Annex - - ii

**From:** C B Reddy <cbreddy@metl.net>  
**Sent:** Tuesday, July 21, 2020 12:31 PM  
**To:** 'zyh'; 'Prabodh Bavalia'  
**Cc:** 'moosa@metl.net'; 'Sandhya'; 'Gireesh'; 'Mohammed Rashid'; 'gd'  
**Subject:** RE: FW: line no 10 lay out for confirmation

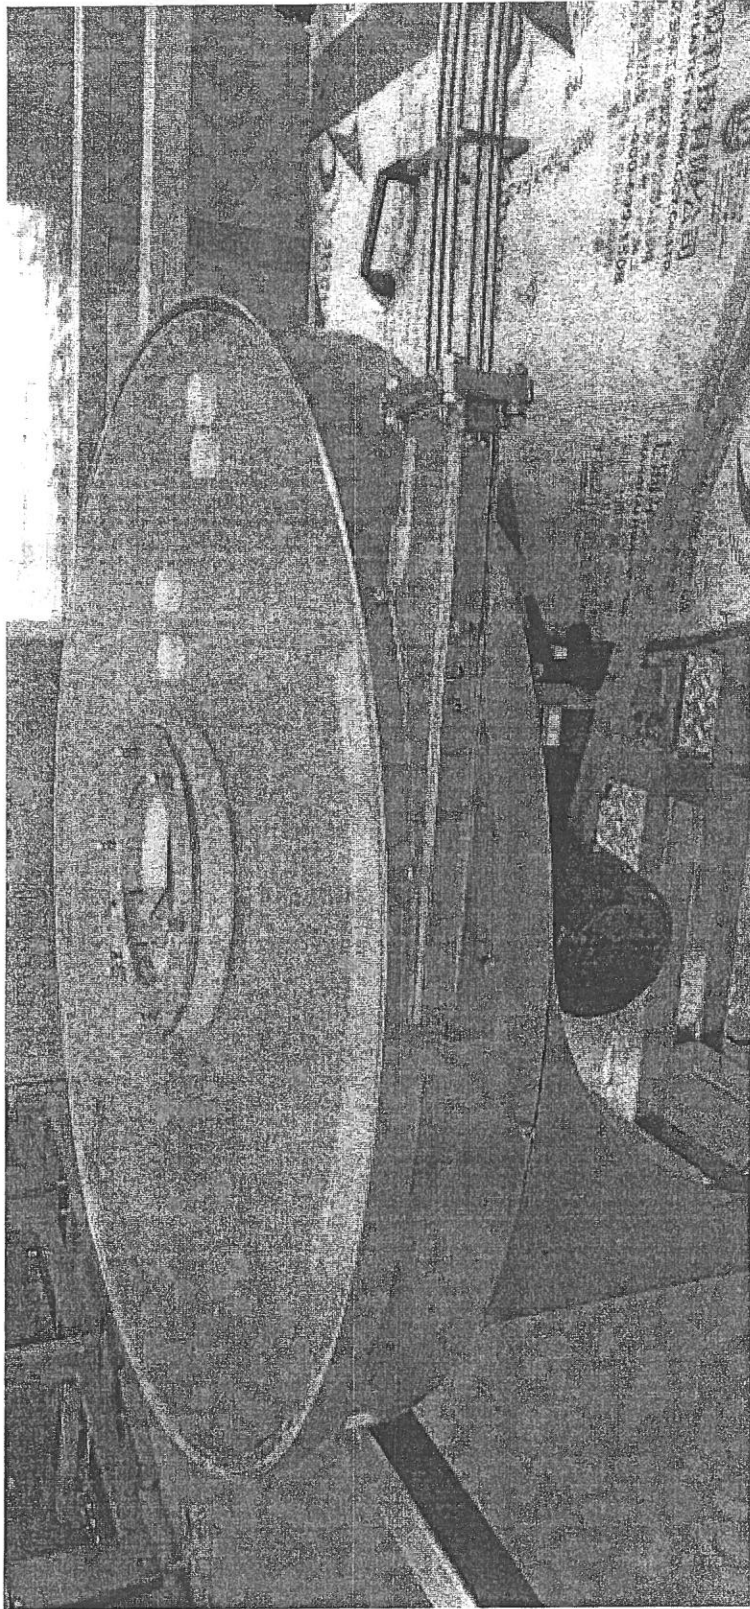
In attached drawing we need following changes:

- BFC orientation as per the attached drawing to fit line in 70\*16 mt area.
- We have shown buffer for labeler and shrink wrapper machine-highlighted in green need to be incorporated by removing excess conveyor after filling.
- After labeler in proposed drawing we can see that conveyor is inclined to optimize space requirement.

Dear sir,  
I have compared our proposal with this drawing in detail.  
The received drawing is completely different.  
The layout is not according to our recommendations.  
I have attached both drawing in PDF format in this email attachment.
